Re: Groundhog No. 5 Stockpile Workplan
Hanover and Whitewater Creeks Investigation Unit- Chino AOC

**Response to New Mexico Environment Department Comments on the Draft
Groundhog No. 5 Stockpile Work Plan for Additional Characterization and Controls,
Hanover/Whitewater Creek Investigation Unit**

Interim Remedial Action Work Plan for Additional
Characterization and Controls

FREEMPORT-MCMORAN COPPER & GOLD		
Groundhog #5 Stockpile Trench Alignment		
Scale: As Noted	Date: 6-2-2014	Notes:
Dept. Environmental Services		Figure 4
Drawn By: SMG	Checked By: PDP

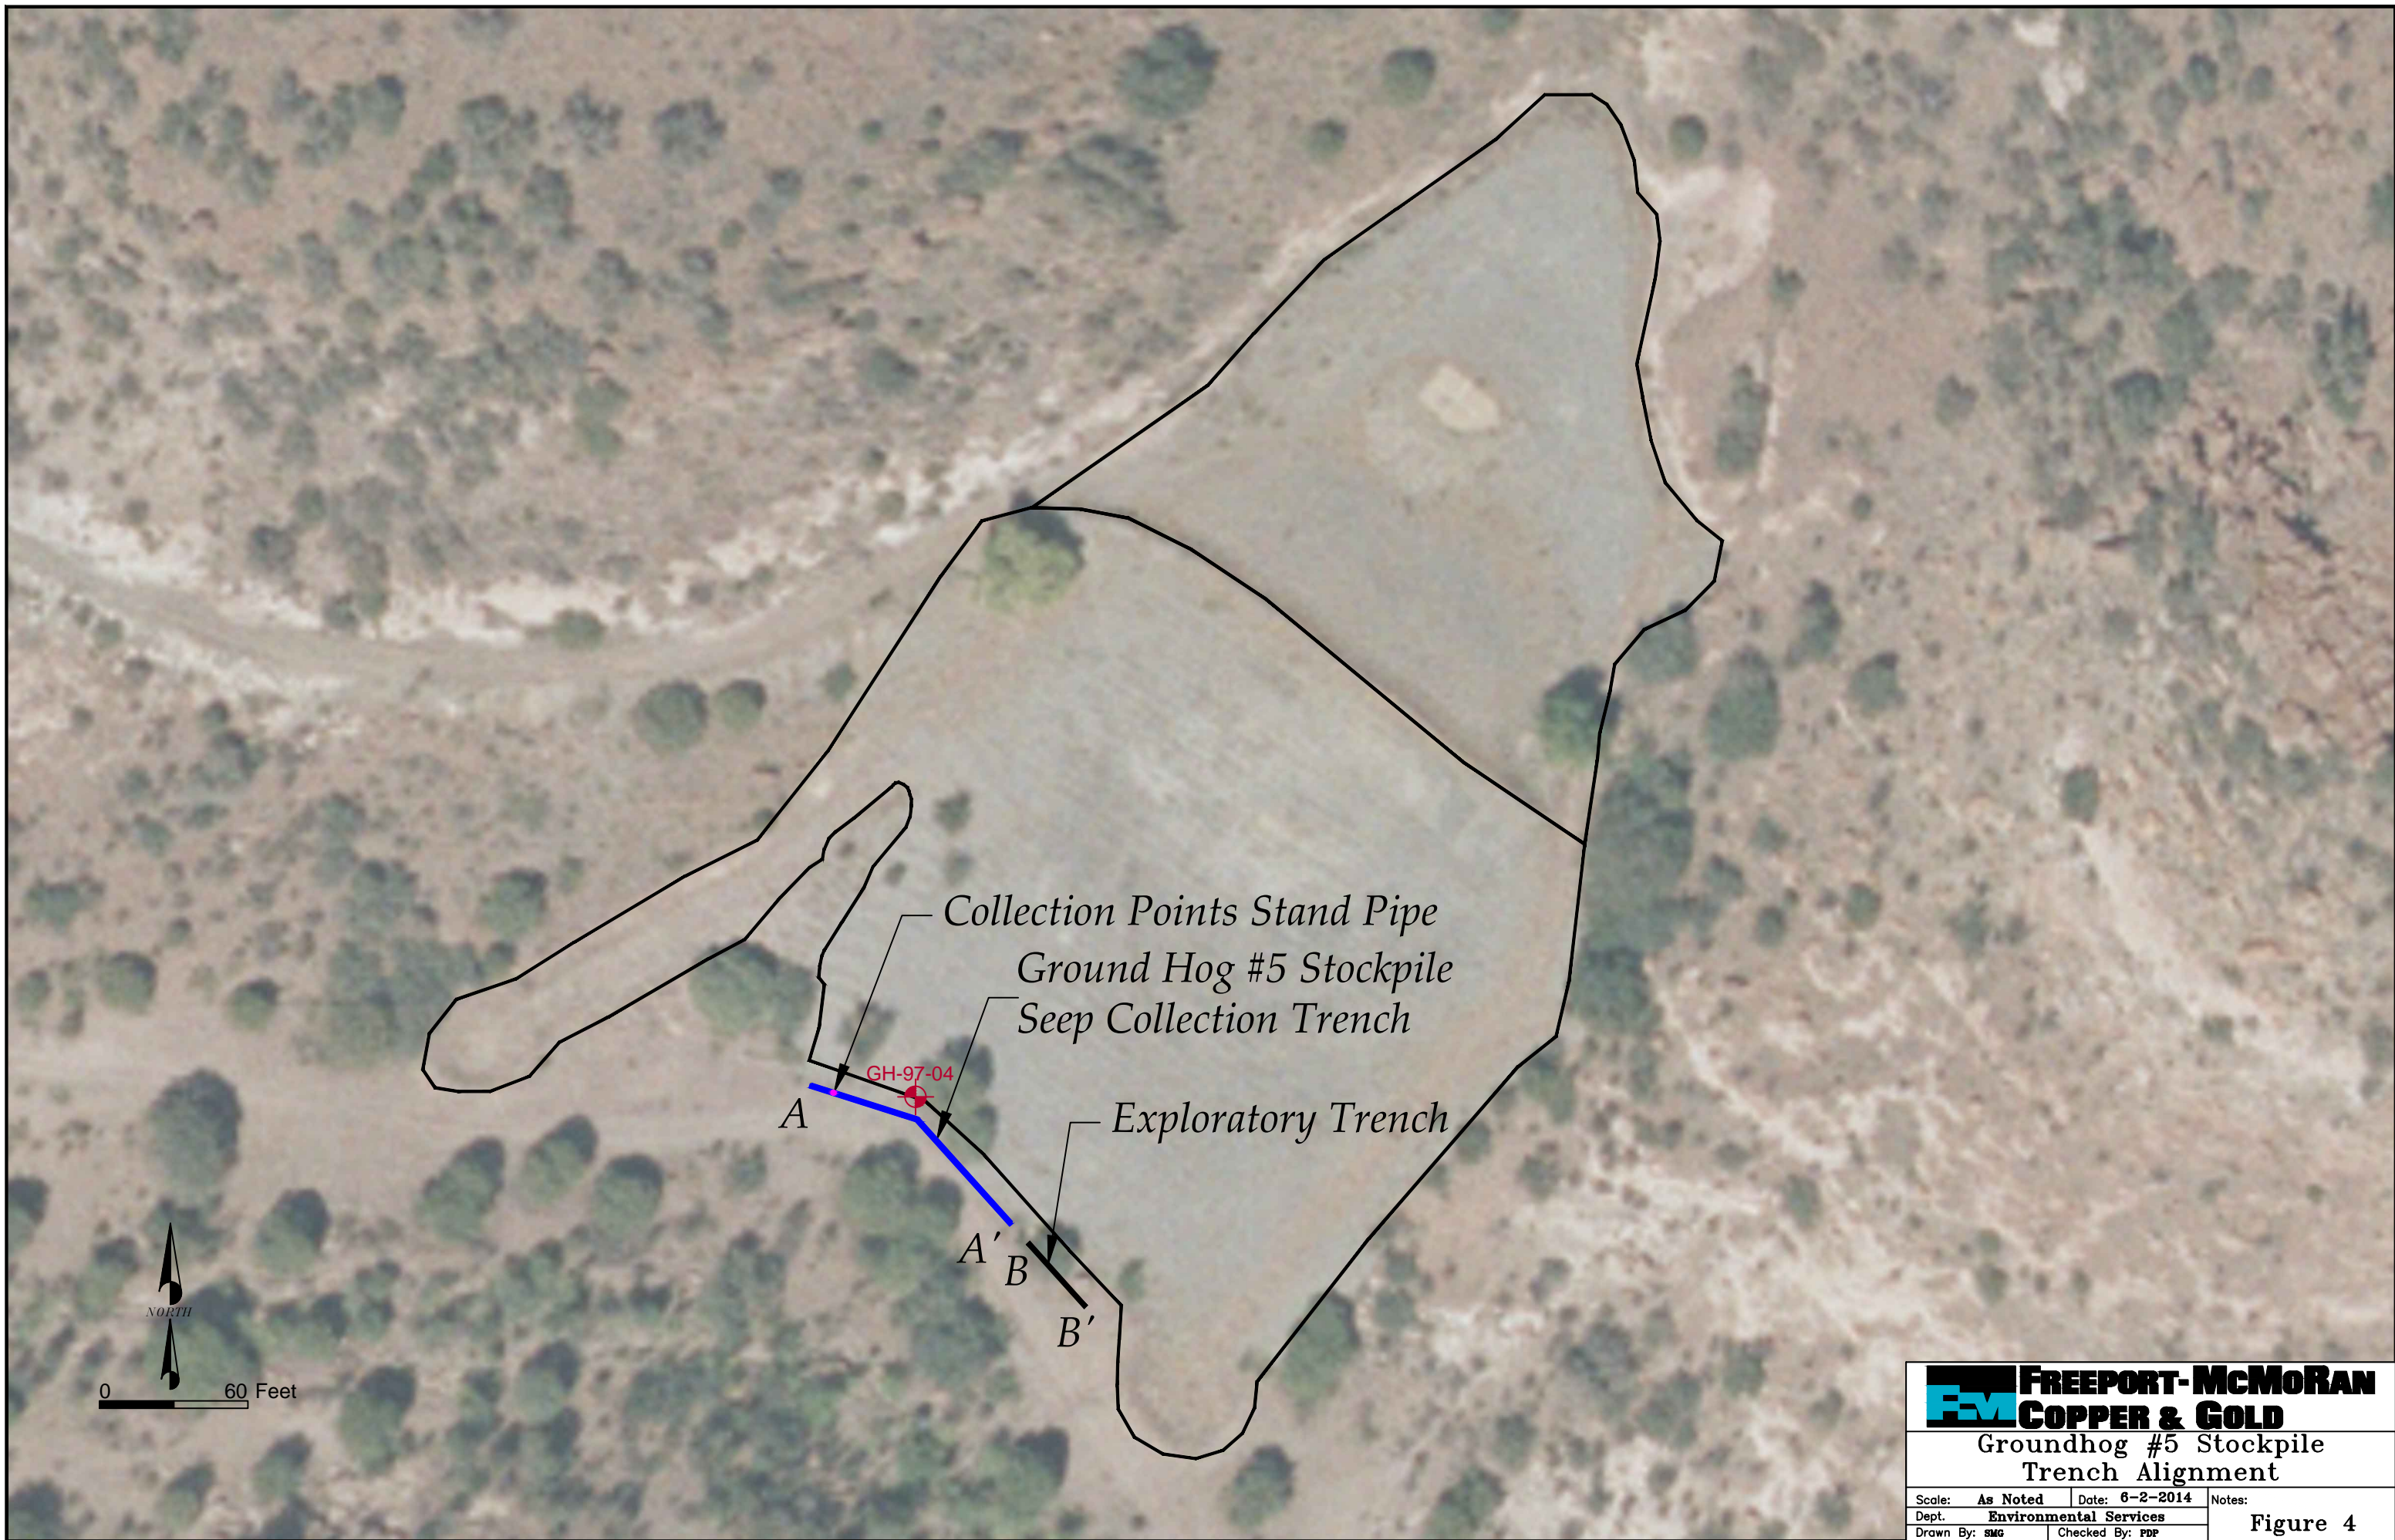
8. Figure 4 is an aerial photograph showing the location of the proposed collection trench. Based on the photo, it is not clear to NMED if the proposed collection trench will extend across the entire toe of the stockpile, including the west end of the stockpile. Please indicate if the proposed seepage collection trench will extend across the entire toe of the stockpile, and if not, the reason why it will not.

Chino Response: The as-built drawing has been included in Figure 4. The draft work plan proposed to extend the trench along most of the toe of the stockpile but as documented in the revised workplan, the trench was field fitted to the actual geomorphology of the bedrock contact that was amenable to the proposed engineering design for the trench.
